West Oxfordshire District Council
Draft Core Strategy – Carterton Strategic Sites
Summary of Agents' Comments, Supporting Technical Reports and
Further Technical Comments

Detailed representations including supporting technical reports were received to the Draft Core Strategy consultation from agents promoting strategic development sites to the east, west and north of Carterton. These representations and any further technical responses received are summarised below.

East Carterton – illustrative masterplans, Savills, March 2011

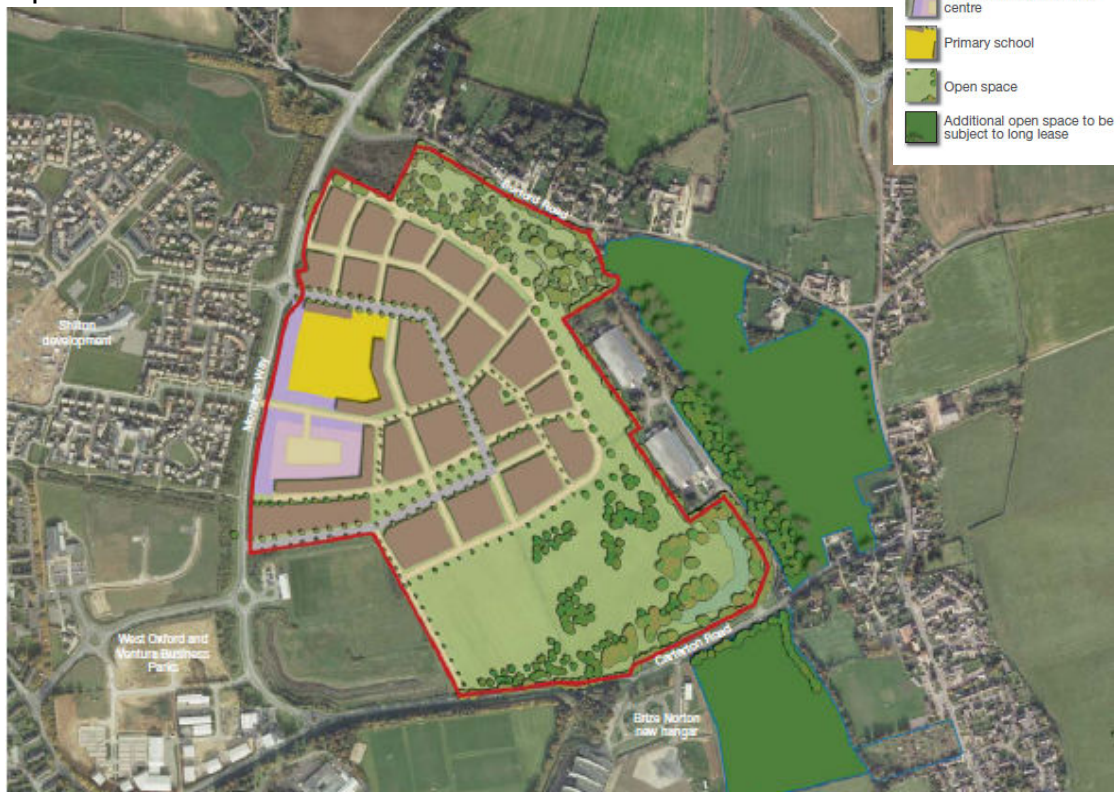
Comments on the Cole Easdon Hydrology Appraisal:

- Need for ground water monitoring for a period of 12 months
- Infiltration testing should be carried out to help determine surface water disposal strategy – use of SUDs supported

- One attenuation pond is not acceptable as would be considered a reservoir under Floods and Water Management Act and neither Thames Water nor WODC would wish to adopt such a structure.

- Developer should be made aware of proposed diversion of drain into Thames Water balancing pond west of the site
- WODC are progressing an attenuation flood control dry pond to the east of the proposed site which will reduce storm flow from drains 1 and 2

- WODC are aware of localised foul sewer flooding and recommend a programme of works for the improvement of the foul sewer system be agreed with Thames Water before a decision is made

- Measures of attenuation would be easier to construct than for the West site because a smaller site and two diversion schemes already planned to control effects of storm water on MOD camp and downstream settlements.

West Carterton - indicative masterplan, West Waddy, Revised June 2011

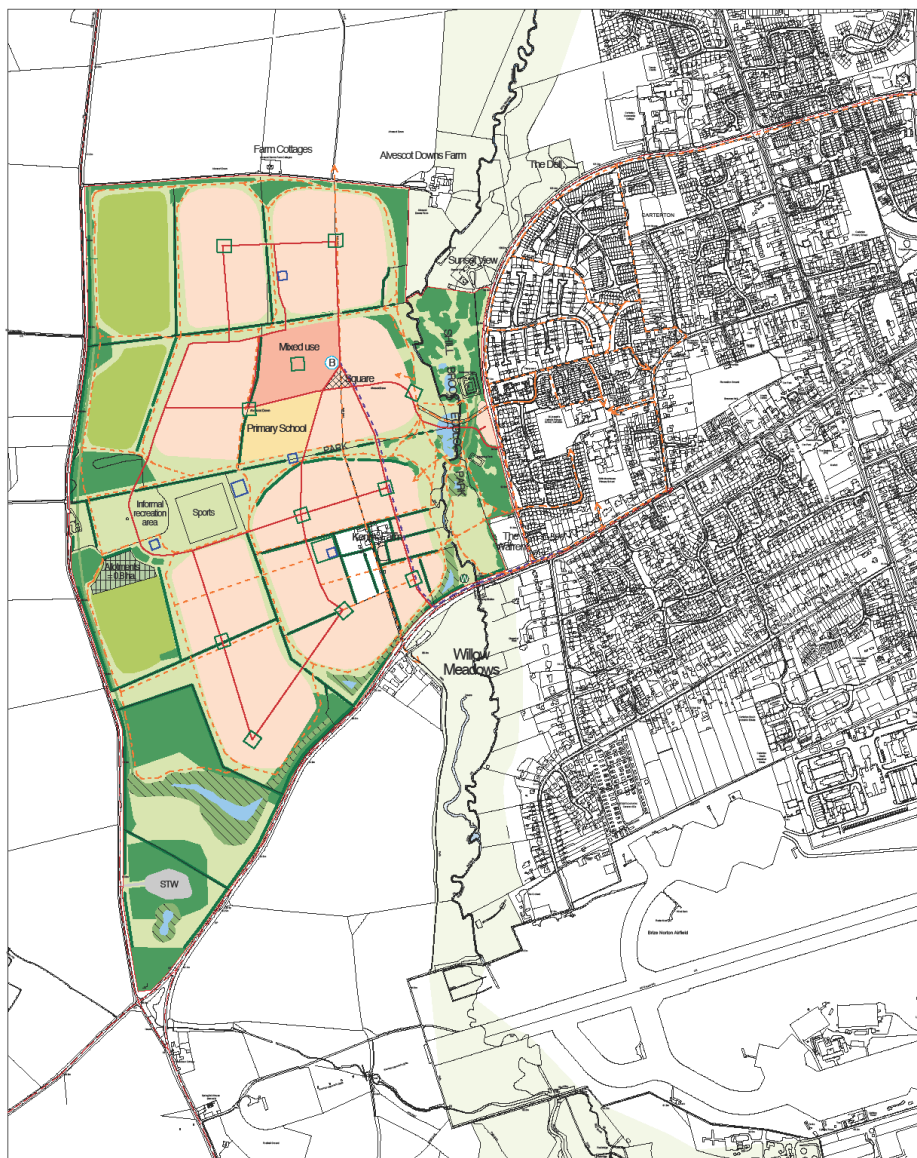
Comments on the Flood Risk Assessment:

- Need for ground water monitoring and for a period of 12 months
- The current proposal for the disposal of surface water states run-off rates and attenuation areas based on the results of one soakage test for a site of 120 Hectares which is not acceptable.
- The site proposal suggests that 20 Ha will be retained as a conservation area and for flood storage. Who will adopt this area, as the riparian responsibilities and conservation obligations will be onerous and expensive to fulfil?
- The overland flow from the West does not seem to be factored into the equations.
- It would also be sensible to carry out further soil investigation including soakage tests, to determine whether infiltration or attenuation is the principal strategy.

Concerned about the proposed culvert/bridge mentioned in paragraph 4.6.1 of the FRA. Unlikely to support the use of a culvert. Would support the construction of a bridge if the design ensured that there was no increase in flood risk. Note that a Flood Defence Consent will be required for works within 8m of a main river.

Kilkenny Farm, North Carterton (Figbury) – illustrative masterplan, Overbury Planning Consultancy, Revised June 2011

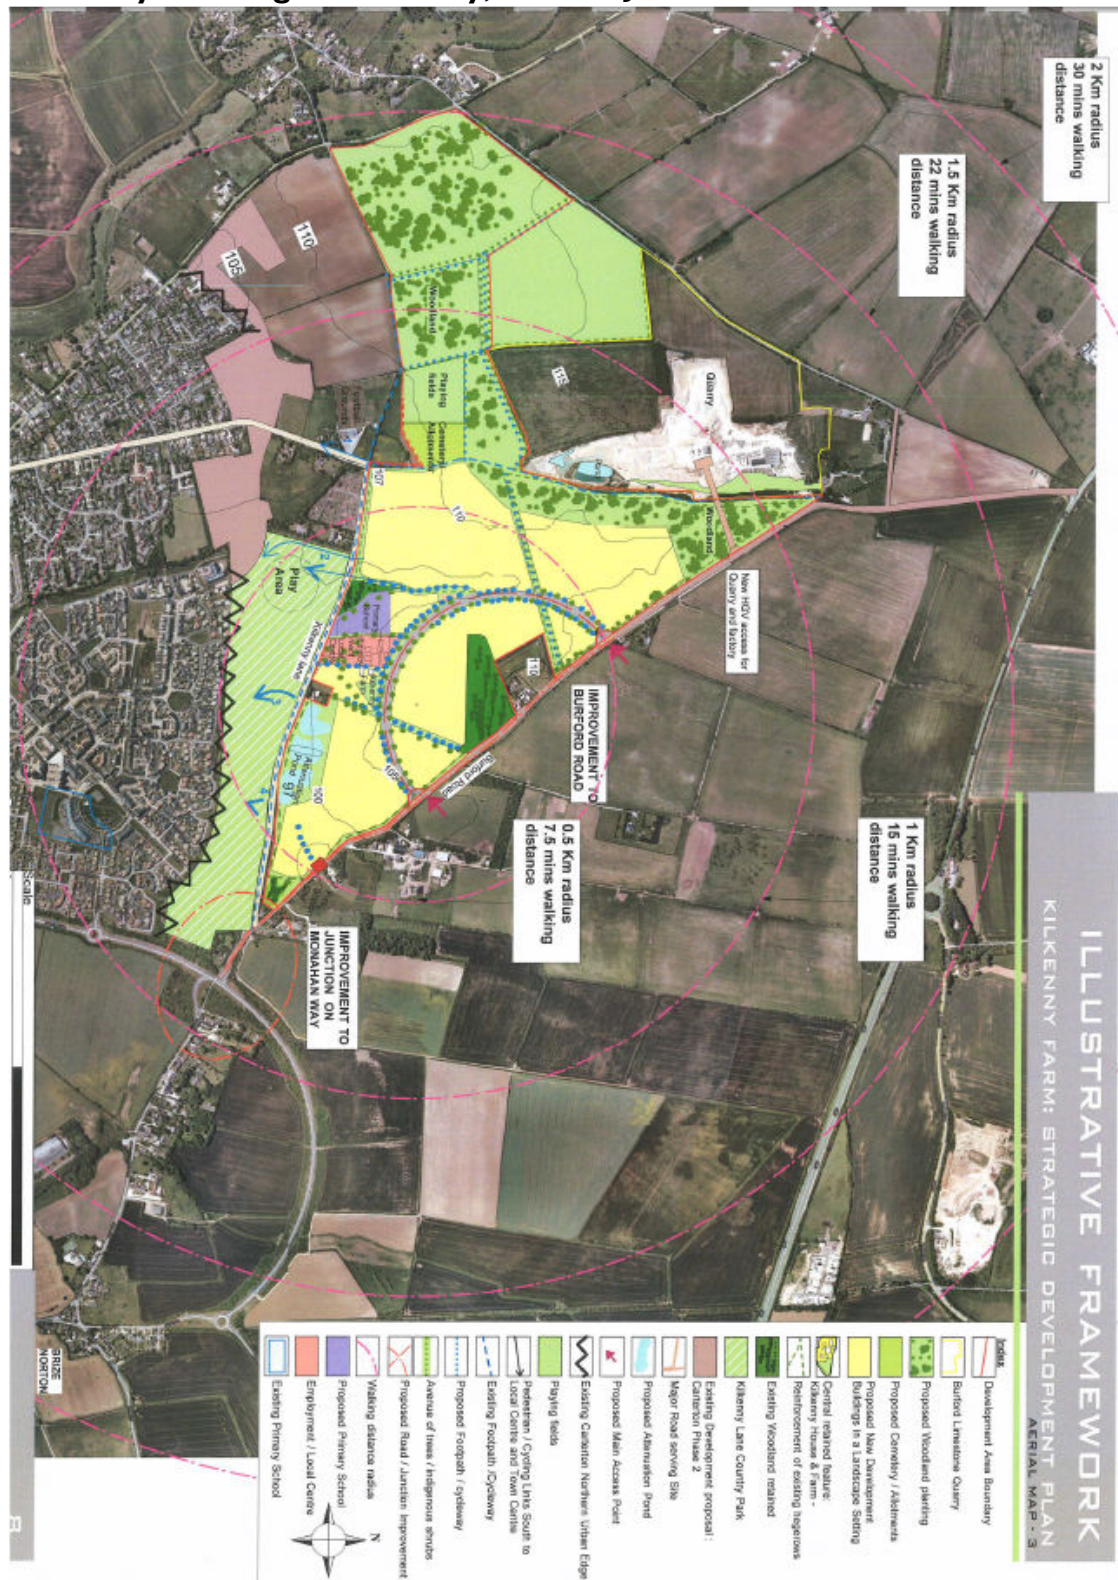
Do not consider that the evidence put forward changes the view that County Council should oppose proposed housing development to the North of Carterton on minerals safeguarding grounds. It is for the development proposer to demonstrate that housing development in this area would not sterilise important mineral deposits. There is no standard buffer distance set in policy and buffer distances are determined on a case by case basis, but guidance in the Minerals and Waste Local Plan is that a distance of 350m may be required. Whilst it is possible that a distance of less than 350m may suffice in this instance, it needs to be demonstrated.

The Figbury proposal is at the head of a delicate catchment regarding flood risk. The proposal to site one large storm attenuation pond next to Kilkenny Lane seems poorly thought out. Kilkenny lane has a critical drainage channel running parallel to it on the north side and has very poor highway drainage which causes flooding at the junction of Burford road already. Any SUDS system would require a contingency overflow system which would ultimately link into an existing undersized system.
